FARRAGUT MUNICIPAL PLANNING COMMISSION

AGENDA

June 15, 2023

INTRODUCTION AND BACKGROUND: At the March 16, 2023 Planning Commission meeting an item on the agenda was to obtain feedback from the Planning Commission on different options to conceal the soil nail wall that has been constructed in association with the Kingston Pike Village, Phase I Planned Commercial Development (PCD) project at S. Watt Road and Kingston Pike.

Wall Profile

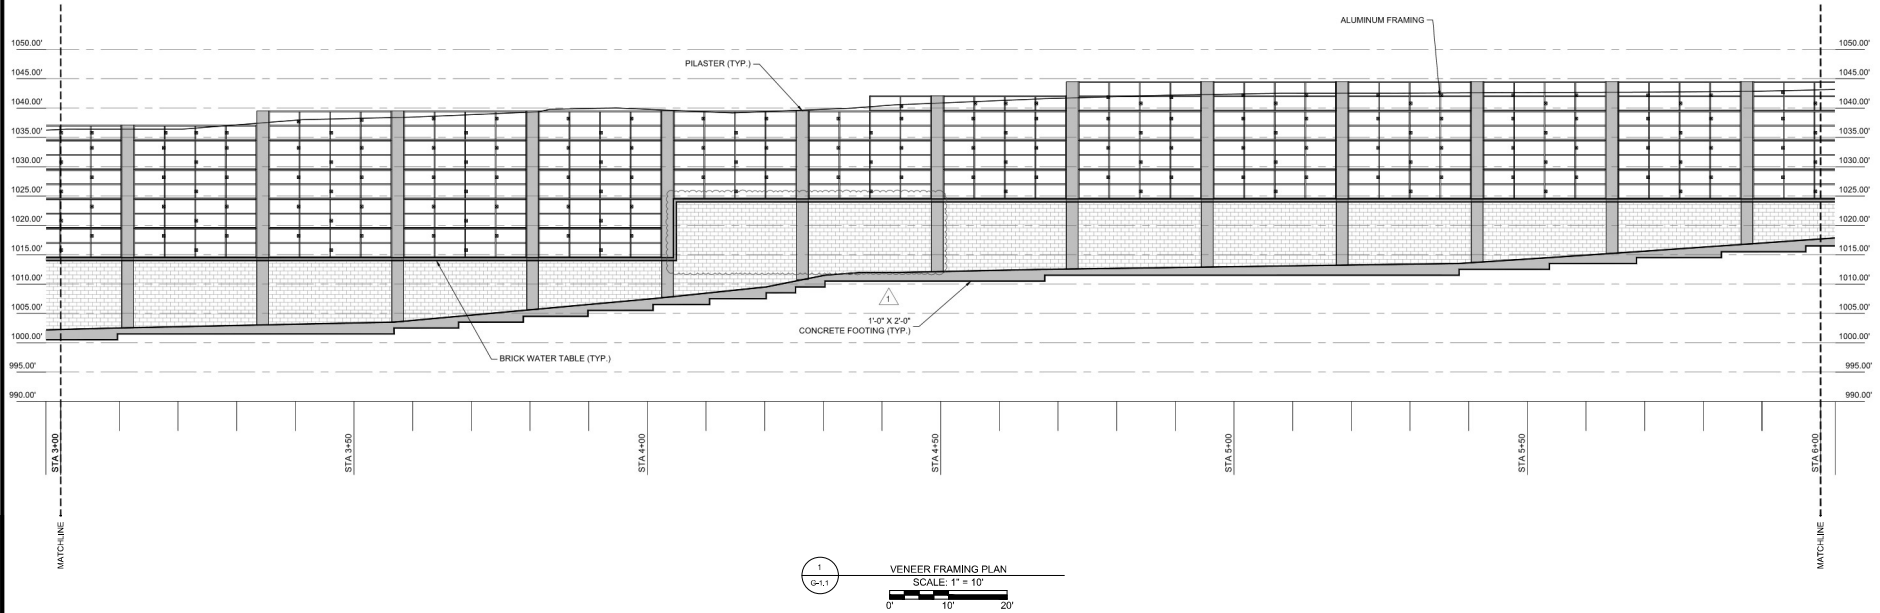
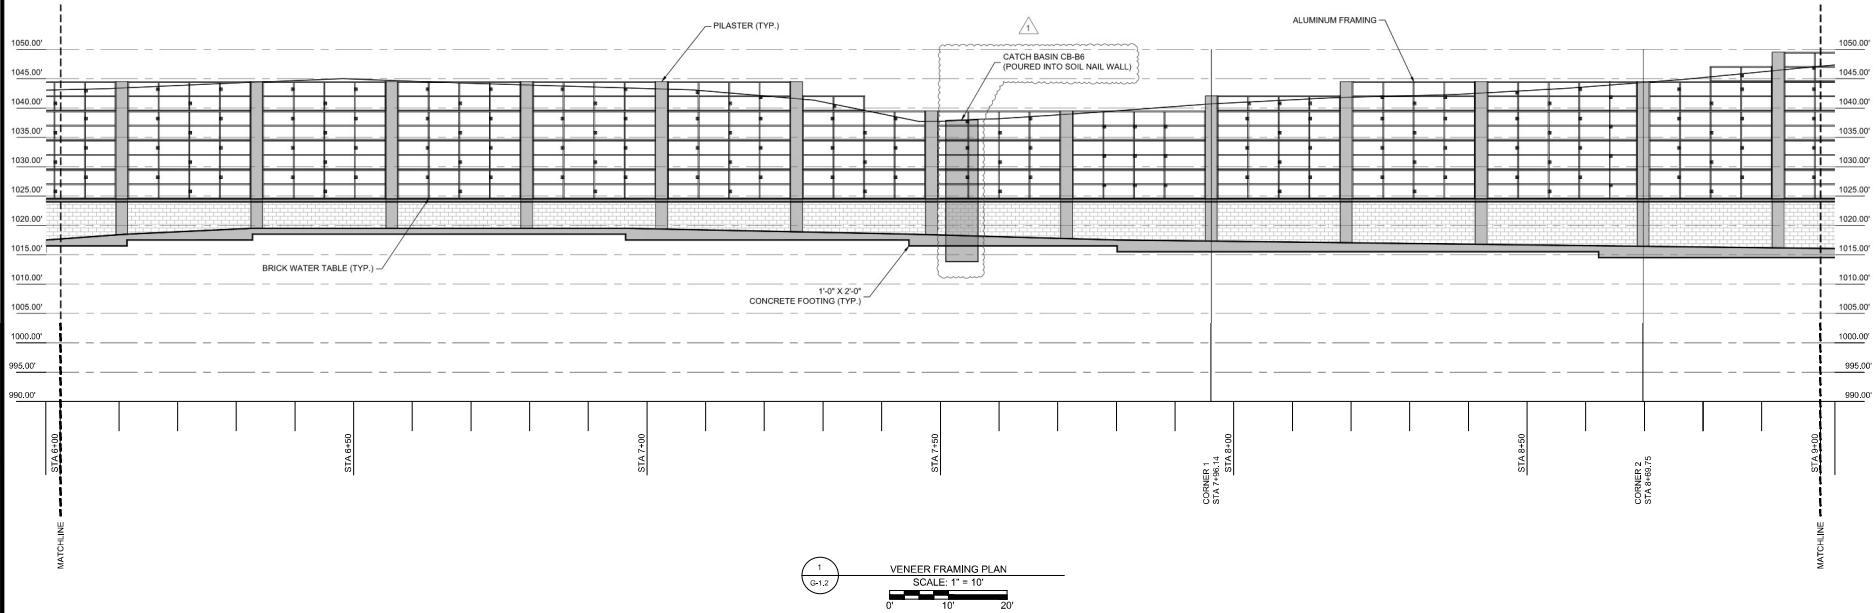
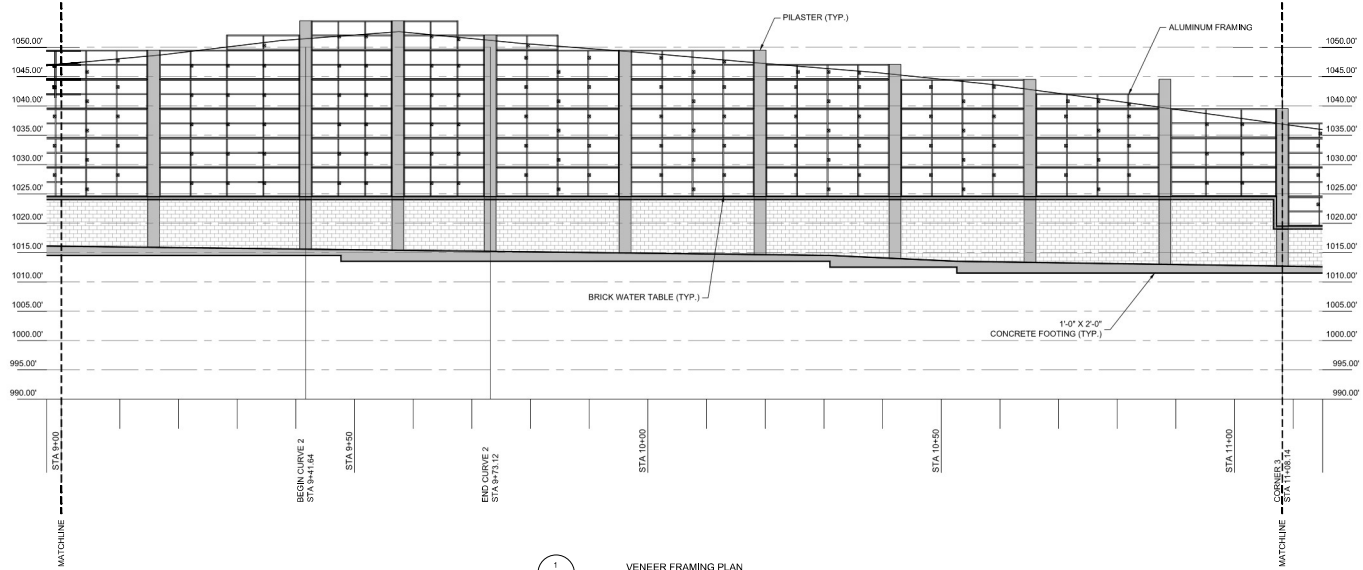
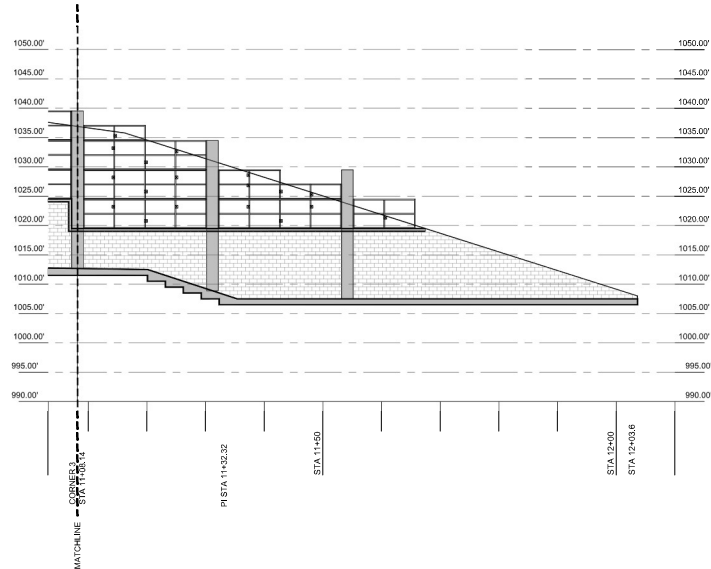
- How much will the framing extend above the wall and where? This should be limited to minimize the apparent height of a wall that is already taller than initially proposed. The view of the wooded hillside above should be preserved as much as possible. The backside of the framing should also not be visible (or screened) from adjoining properties/areas, particularly along the east and west flanks of the wall. – **The top of the framing will have to be field modified to minimize the height as much as possible and still cover the soil nail portion. The design was based off standard panel sizes and custom sizes will be made as required.**

- What is grade of concrete flume in this area? Has depth been checked? – We don't have the exact grade at the location in question. The original topo used by GBS was very inaccurate and we will have to field adjust flume grades to ensure drainage.
- Extend brick at this location – Noted, no problem.

- Please show catch basins A6 and B6 – Noted. A6 was eliminated by GBS due to incorrect topo.

Supplemental Drawing - Site Grading & Drainage Plan - Soil Nail Wall

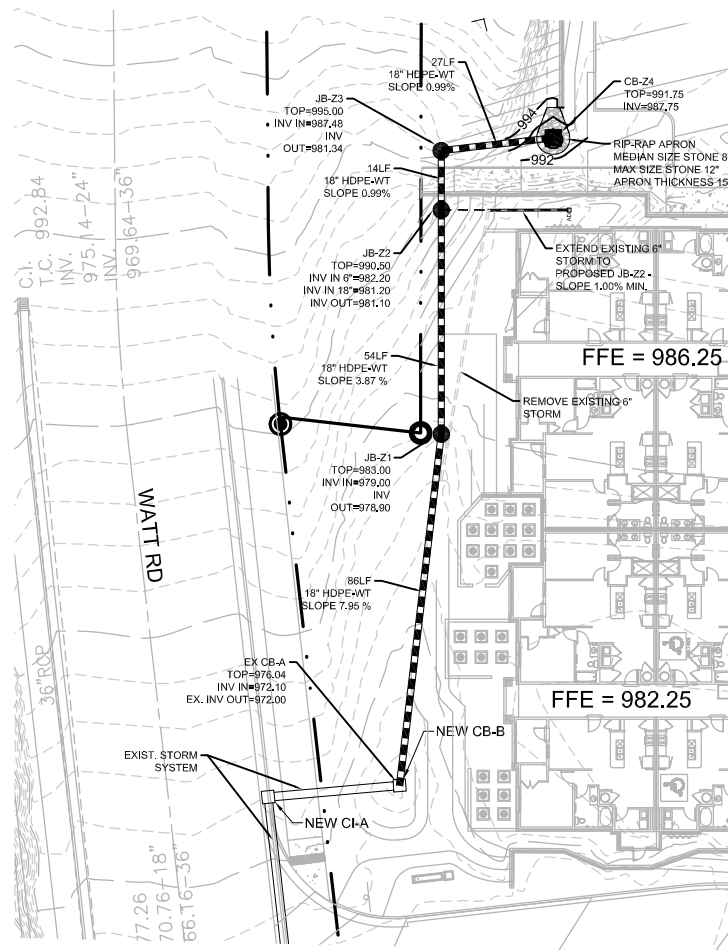
- Approximately 640' of concrete flume is draining to this end of the wall. How is this runoff being collected? – **Storm drain inlets and piping have been added to pick up the draining from each end of the soil nail wall. Refer to SD-32 (pg 9) and SD33 (pg 10) of the plan set.**

- Approximately 250' of concrete flume is draining to this end of the wall. How is this runoff being collected? - Storm drain inlets and piping have been added to pick up the draining from each end of the soil nail wall. Refer to SD-32 (pg 9) and SD33 (pg 10) of the plan set.

THE PURPOSE OF THIS SUPPLEMENTAL DRAWING IS TO ADD STORMWATER INLETS AND PIPING AT THE END OF THE CONCRETE FLUME ON THE EAST SIDE OF THE SOIL NAIL RETAINING WALL.

PROPOSED AWNING METAL / BRICK COLORS

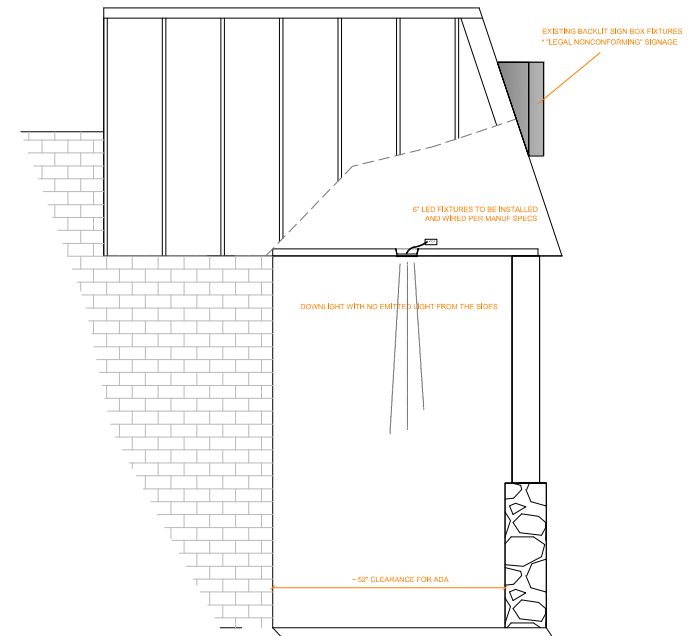
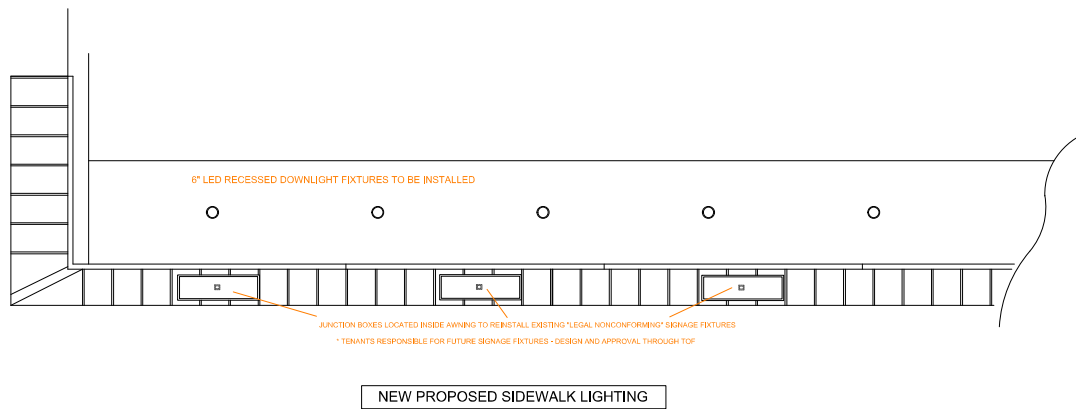
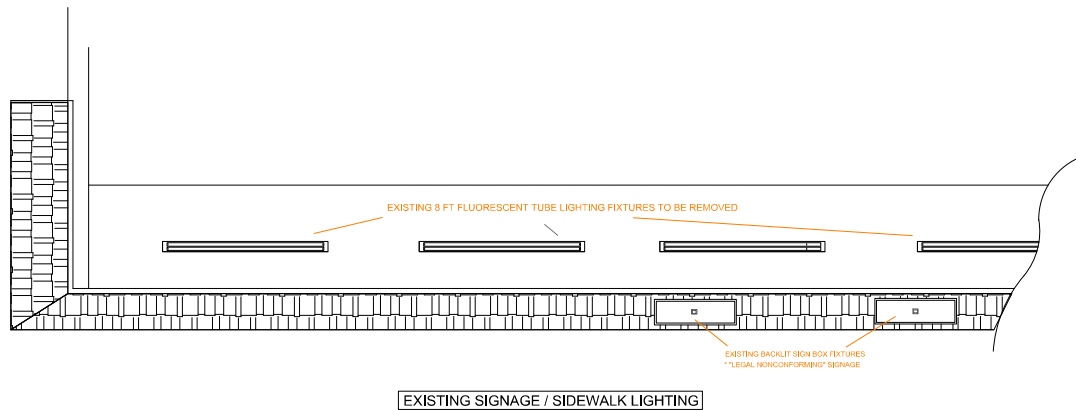
Please include a cut sheet detail for the proposed light fixture and include the Kelvin temperature. Please show how the lights will be recessed into the canopy so that no light is emitted from the sides and all lighting is directed downward.

1. The proposed color of the building and awning will need to be coordinated with the tenants so that signage is legible. The proposed light gray color would necessitate signage that is black to establish proper contrast.
2. Since this building is within the MUTC, should the brick be painted or retained in its natural color? A dark brown awning that would closely match the color of the brick would be more appropriate.
3. Please show the entire building and include a cross section showing the proposed canopy. The canopy should be extended so that signage may be installed perpendicular to the ground. This would improve signage visibility and create more options for mounting and providing signage that is compliant with the MUTC.

Please ensure that you have at least 4 feet of clearance between the proposed columns and the building so that there is wheelchair accessibility.
